STATE OF NORTH CAROLINA
DEPARTMENT OF TRANSPORTATION

March 10, 2014

SUBJECT: **Application for Section 404 Individual Permit, Section 401 Water Quality Certification, and Isolated Wetlands General Permit** for the proposed NC 24/27 Troy Bypass from west of SR 1138 (Dairy Road) to just east of Little River, Montgomery County, Division 8. TIP No. R-0623.

PROJECT REFERENCE NO.	SHEET NO.
R-0623	5
R/W SHEET NO.	
ROADWAY DESIGN ENGINEER	HYDRAULICS ENGINEER

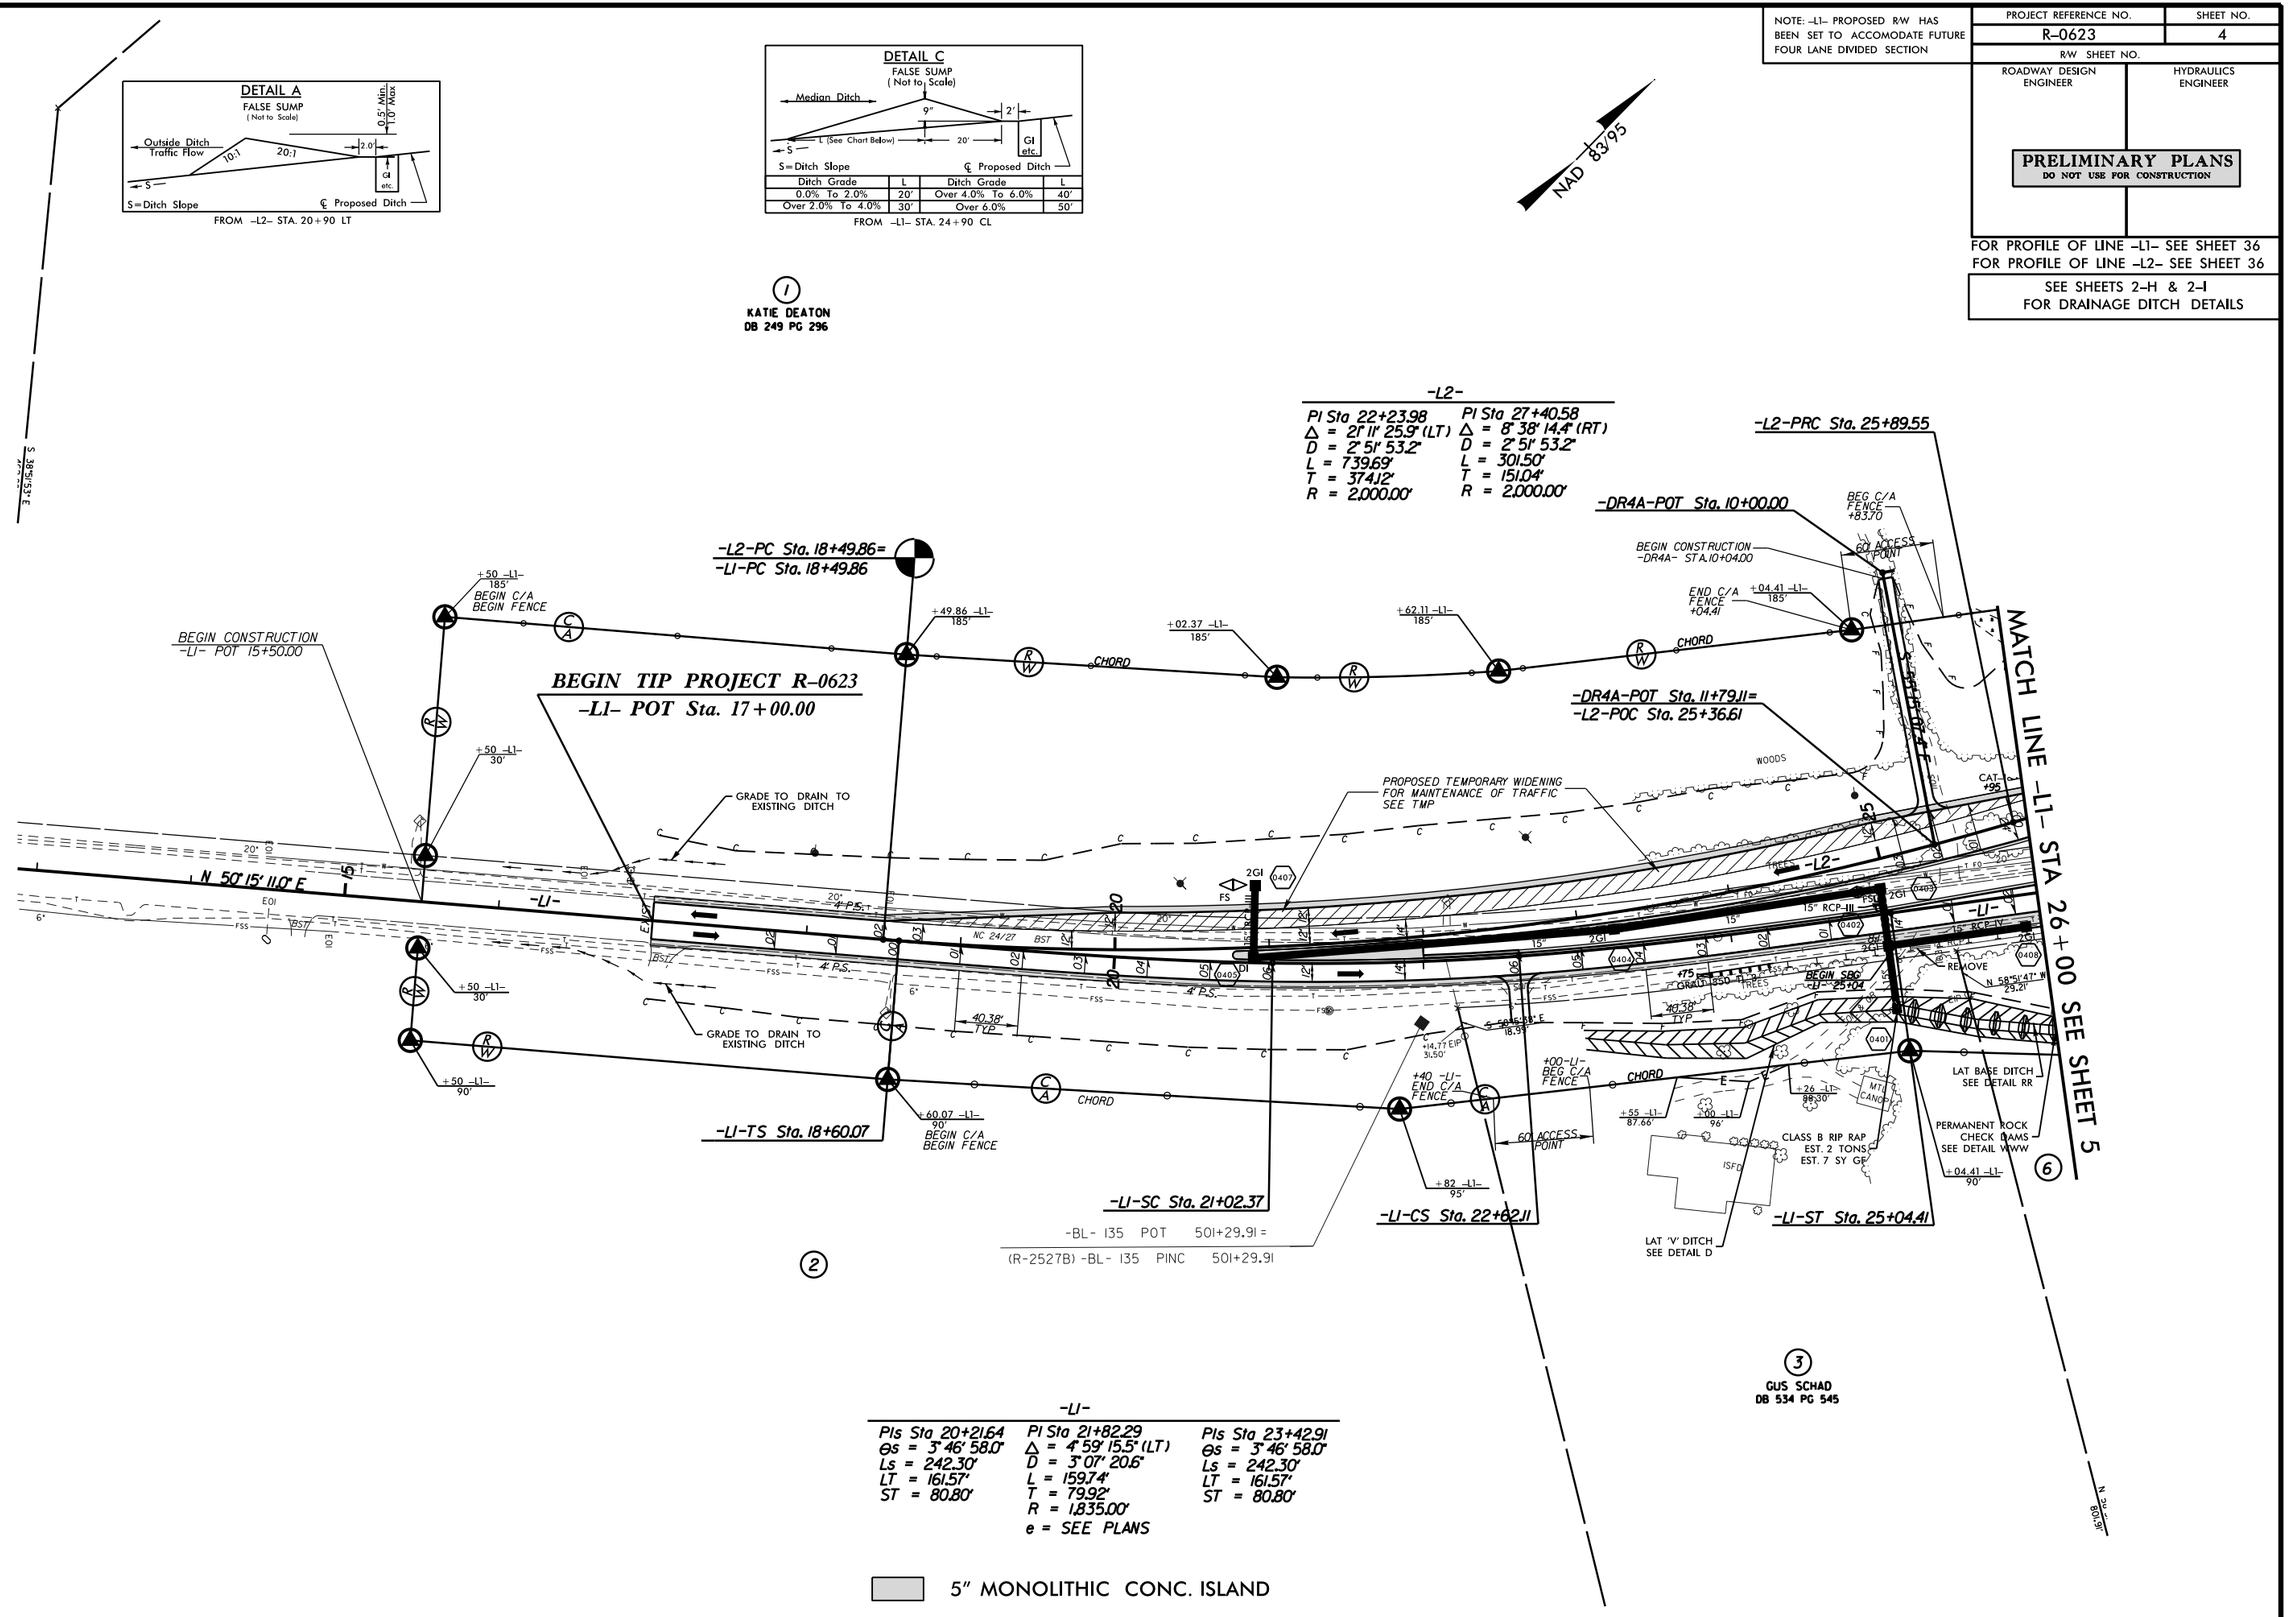
- Include bank stabilization impacts to summary sheet for rip rap at outlet. – **done included**
- Check stream impacts, separate stream impacts and bank stabilization. – **done checked**

- Stream should be labeled as a JS stream. **– done updated**
- Show any stream impacts on summary sheet **– done updated**

FOR PROFILE OF LINE -Y2- SEE SHEET 51
FOR PROFILE OF LINE -L- SEE SHEETS 37 AND 38

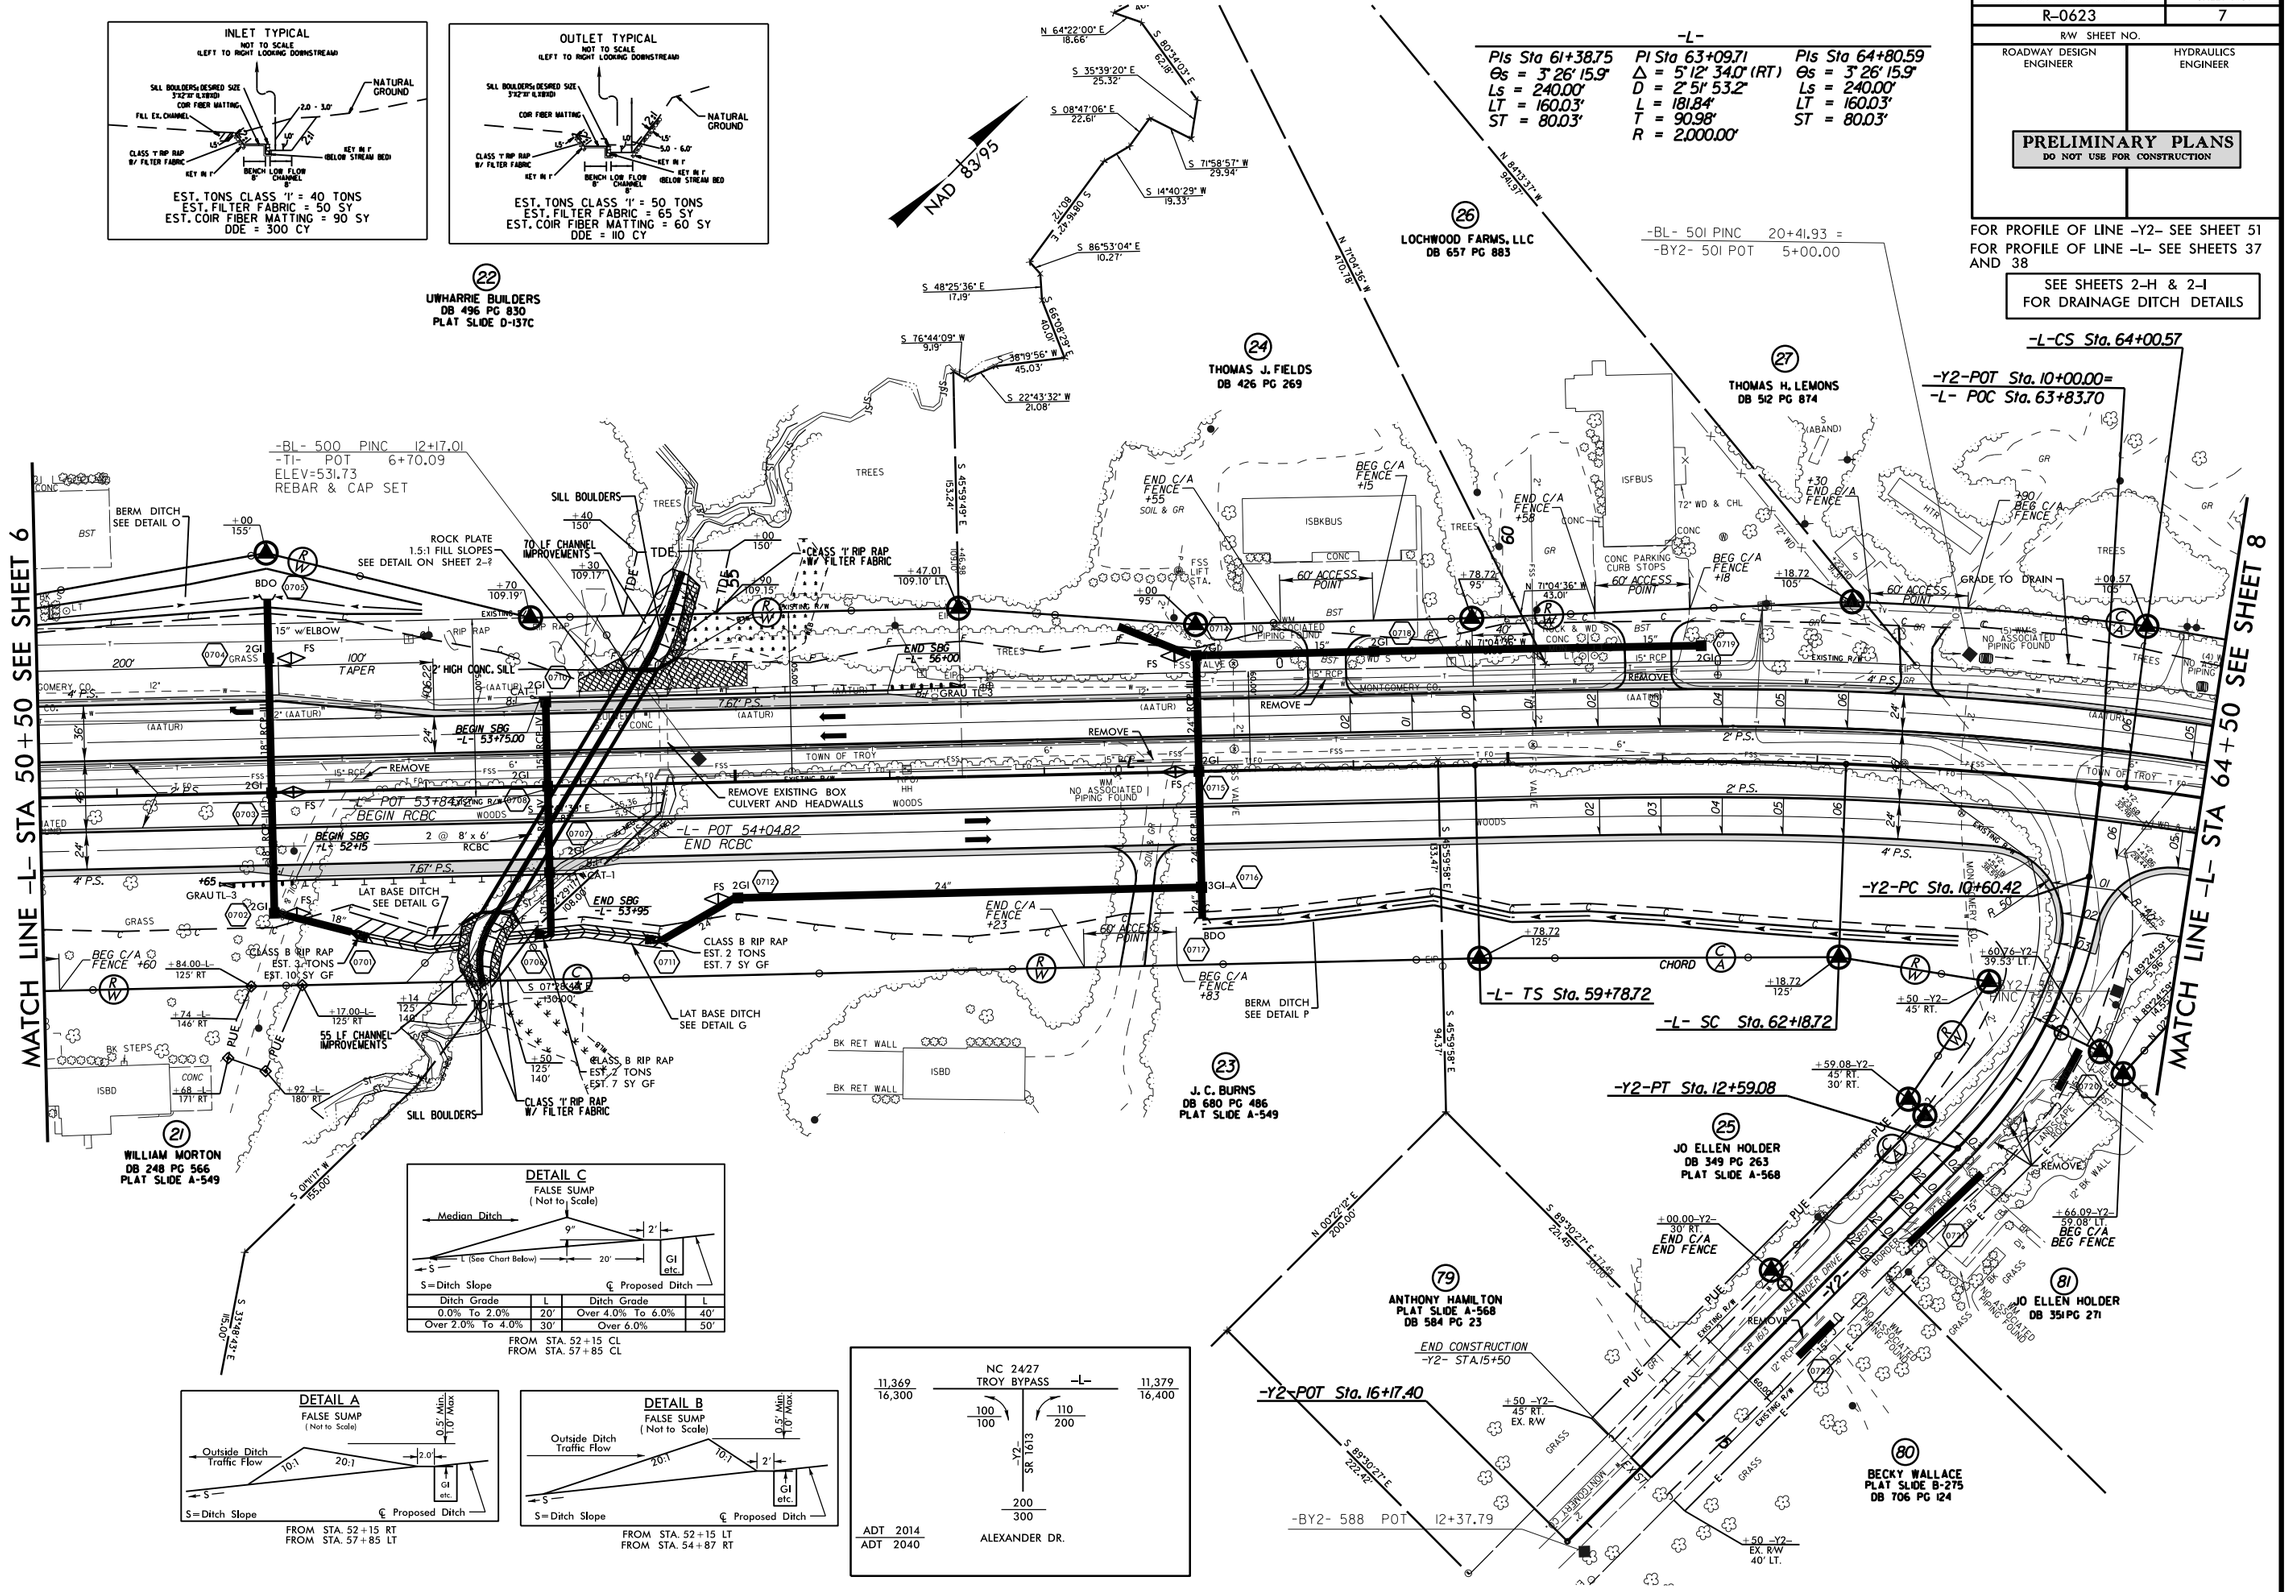
- At the inlet end of the proposed 60" pipe there are 2 stream branches that flow into the pipe. The southernmost branch that is existing from the existing 18" pipe is not a JS and the impacts should be removed from the summary. **– done removed**
- The length of the tail ditch for the 60" pipe should be added to detail "T". **– done added to detail.**
- Bank stabilization should be added to the summary sheet. **- done**
- If the channel at the outlet is being re-shaped, the impacts should be included as a permanent impact. **– done included as permanent**
- Extend the impacts to the C/A line **- done**

PROJECT REFERENCE NO.	SHEET NO.
R-0623	33
R/W SHEET NO.	
ROADWAY DESIGN ENGINEER	HYDRAULICS ENGINEER

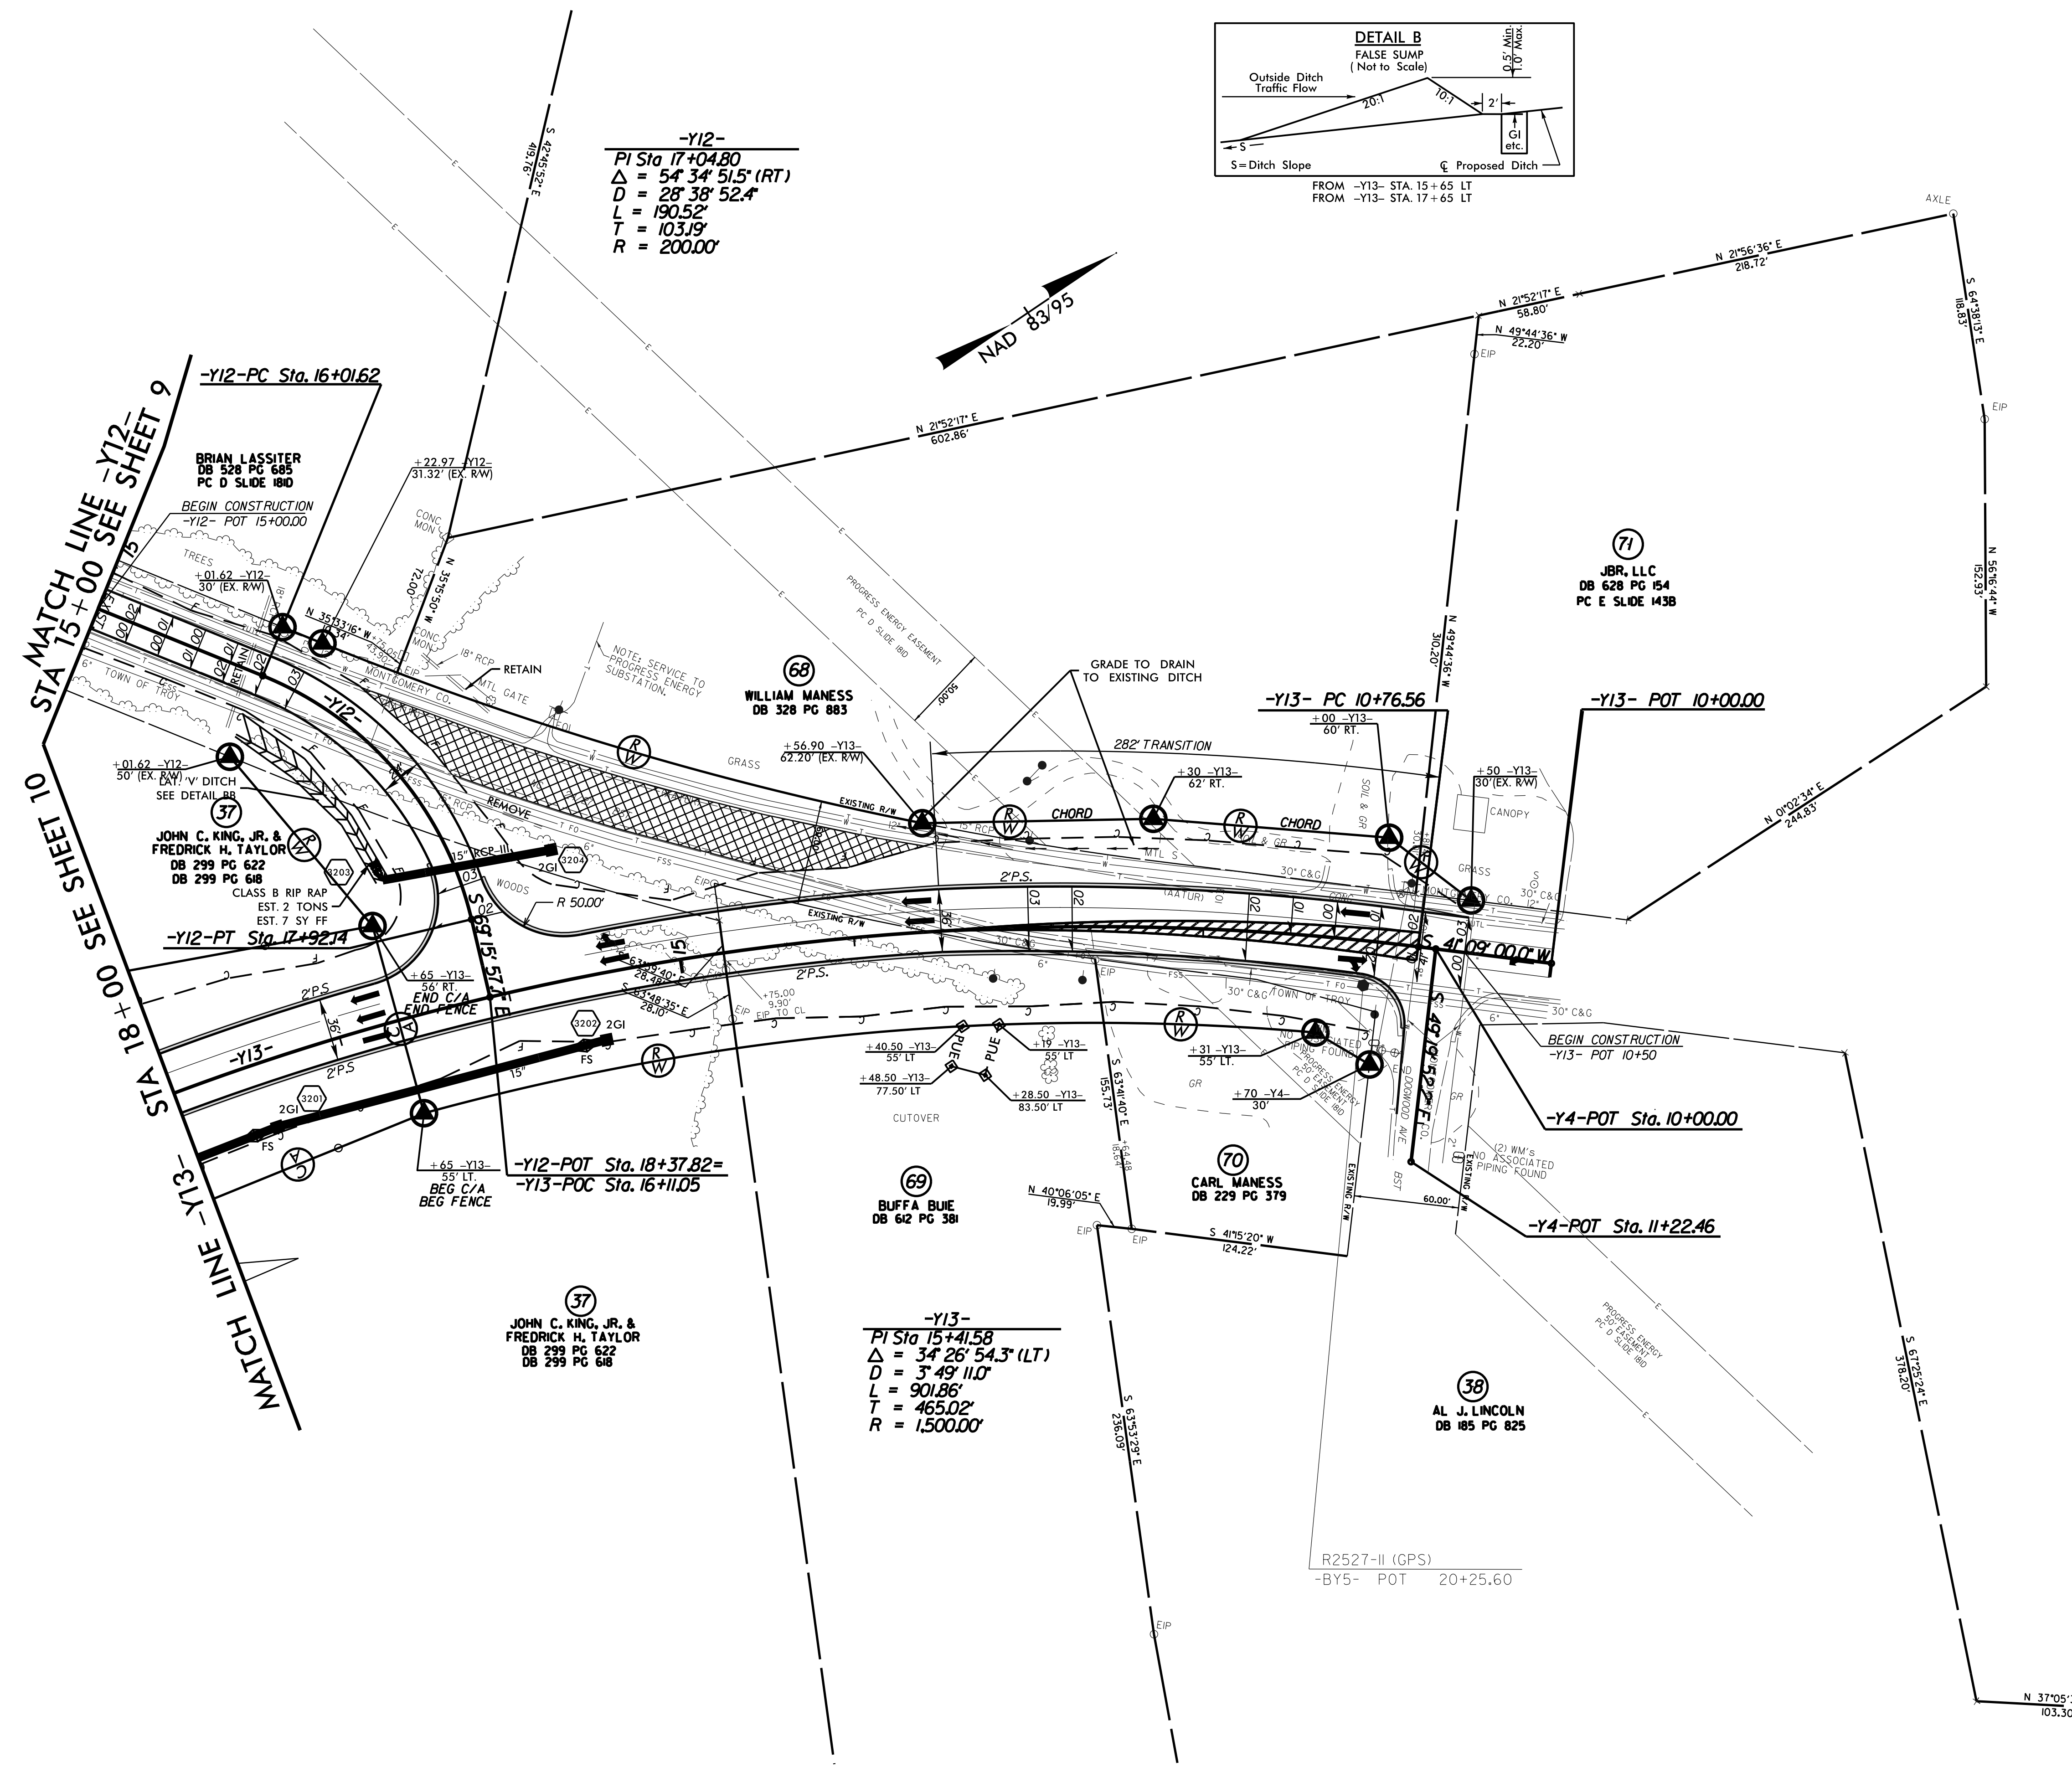
- Impacts to surface water and wetlands from proposed roadway fill, cross pipe and lateral ditch.
- The JS starts on the downstream (south) side of the area of wetlands on the north side of –Y7-.
- On the south side of –Y7-, the channel branch on the west side is not a JS. The east channel is a JS and should be labeled as such by Location and Surveys.
- There is a pond on the north side –Y7-. Location and Surveys is to pick up pond to show on the plans.
